ADDENDUM NO. 01

PROJECT: Gallatin Town Hall Renovations

CPL PROJECT NO. R22.16758.00

DATE: April 8, 2024

1
E003
ELECTRICAL SITE PLAN
SCALE: 1" = 10'

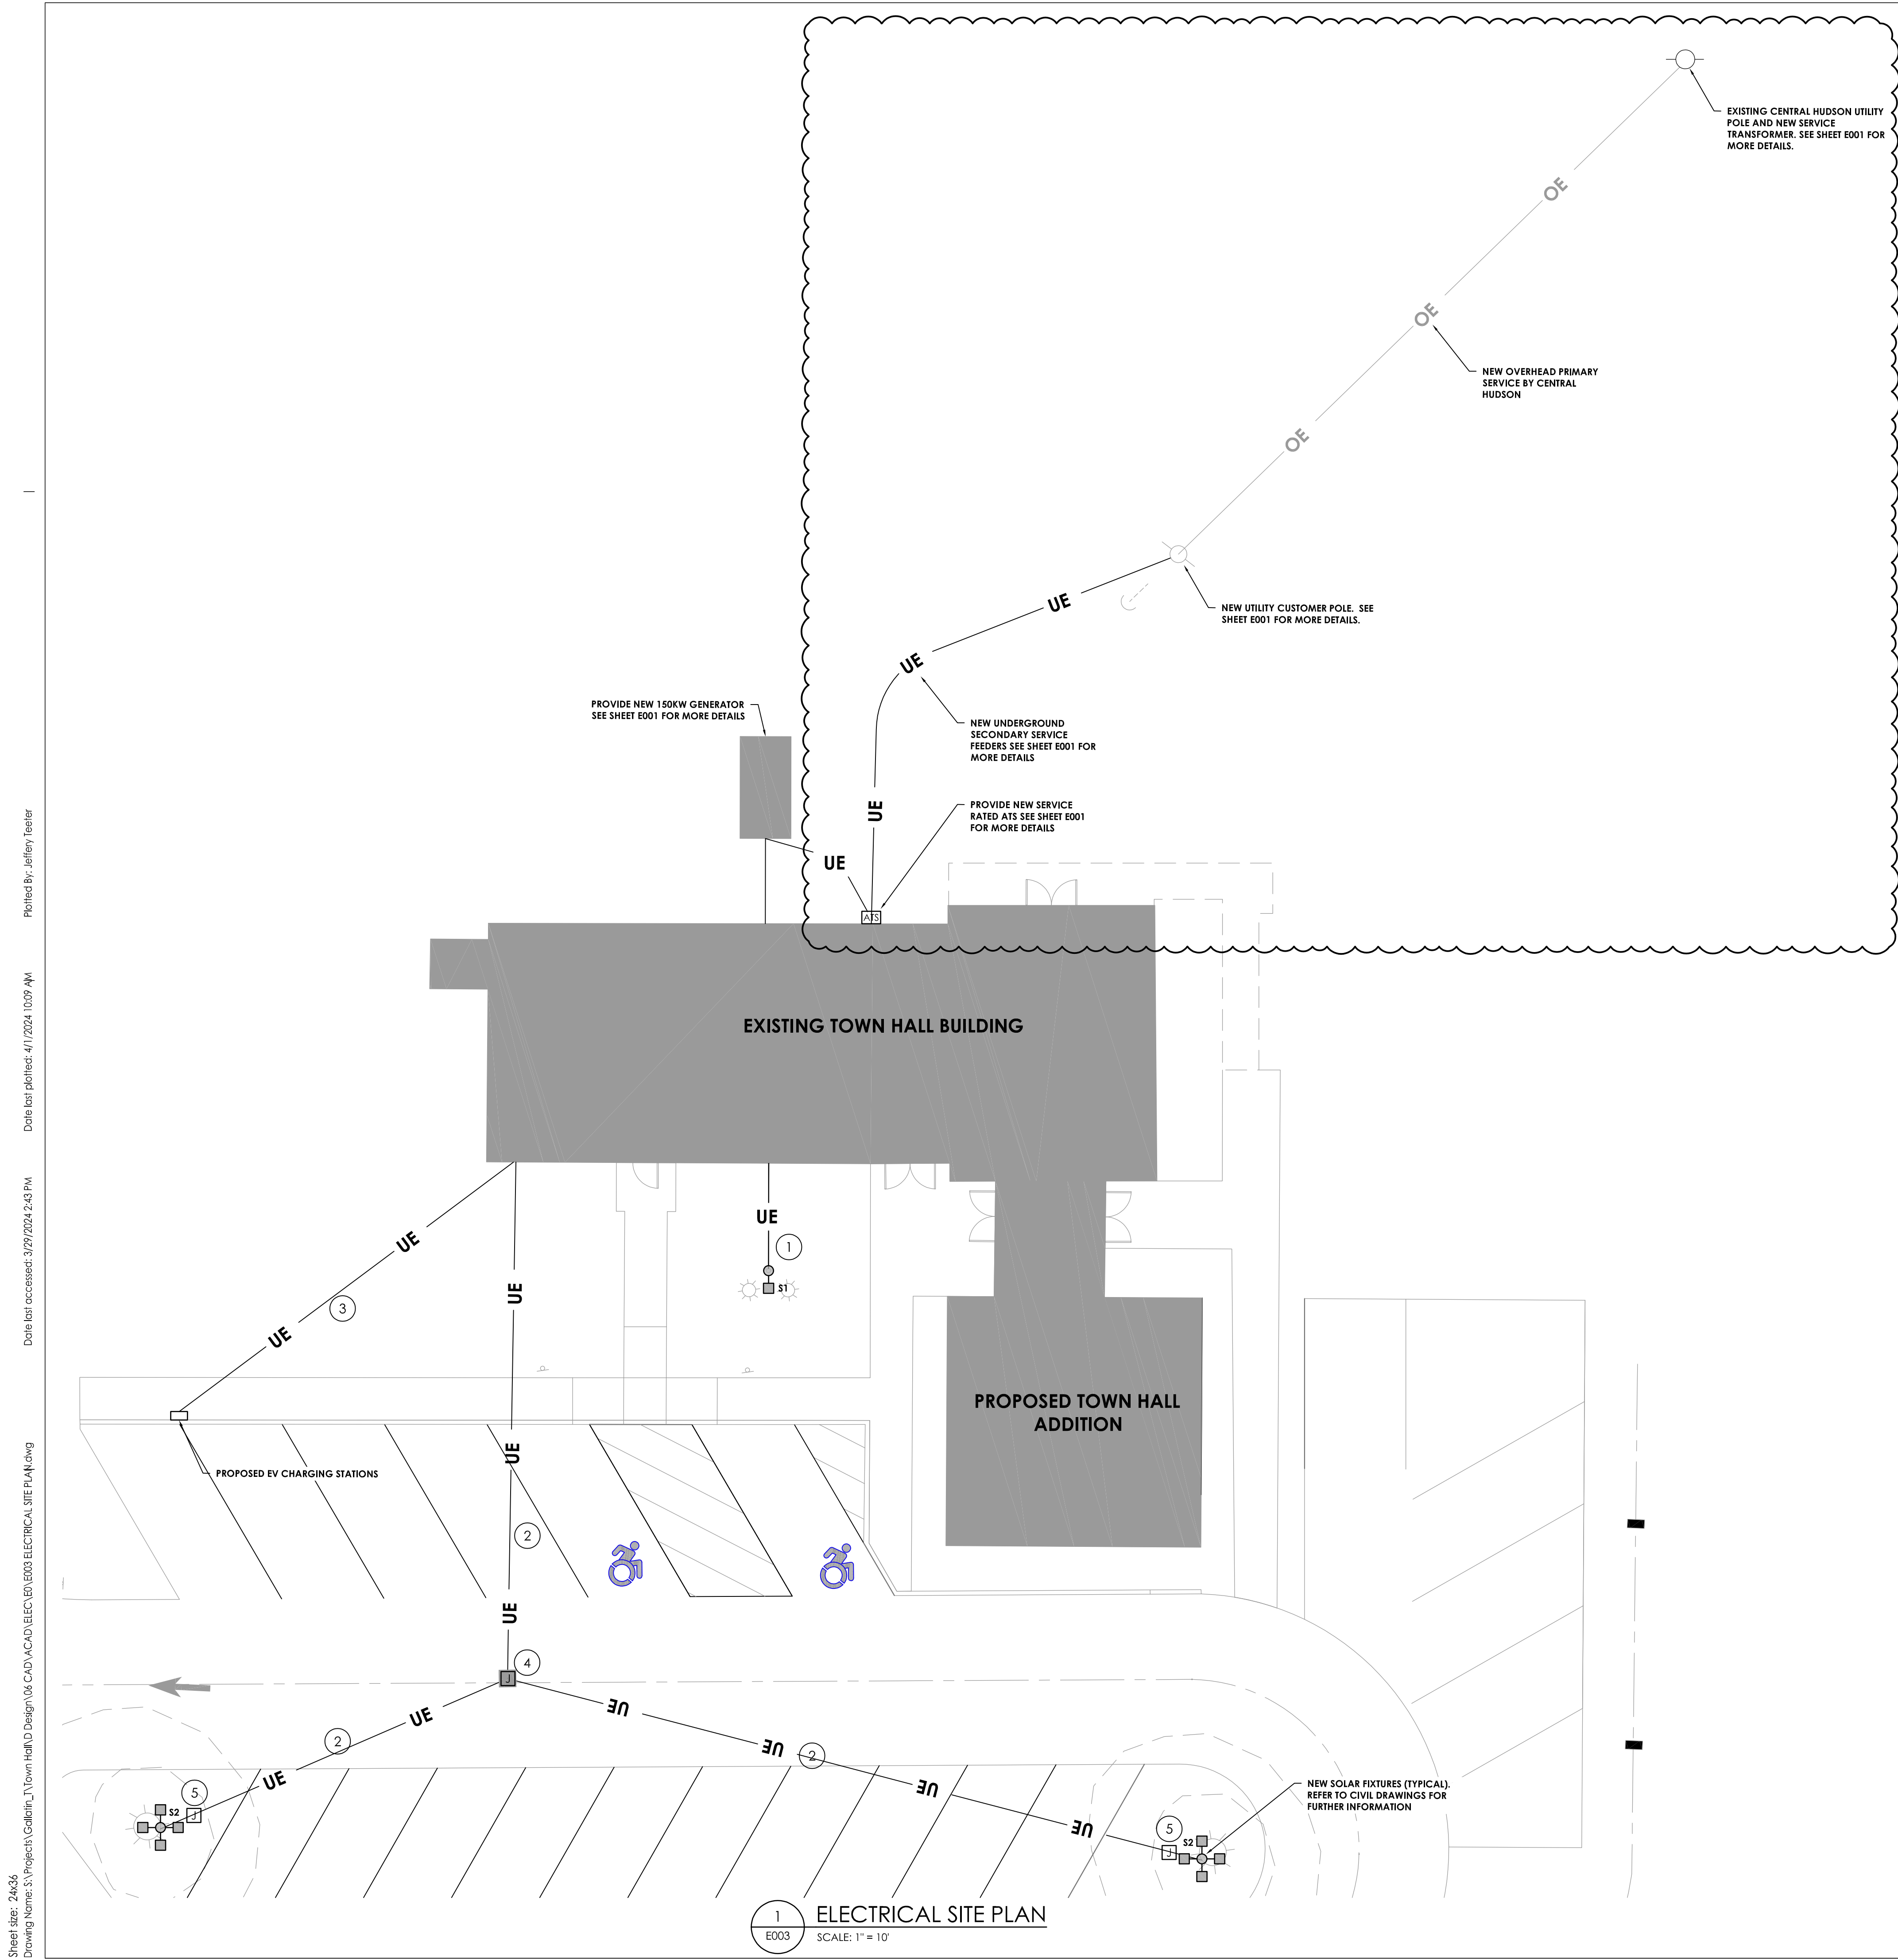
9. *Who is providing an electrical car charging station?*

The town is providing the electric charging station (could be a future install after project is completed). Electrical Contractor is responsible for providing power as indicated on drawing E003.
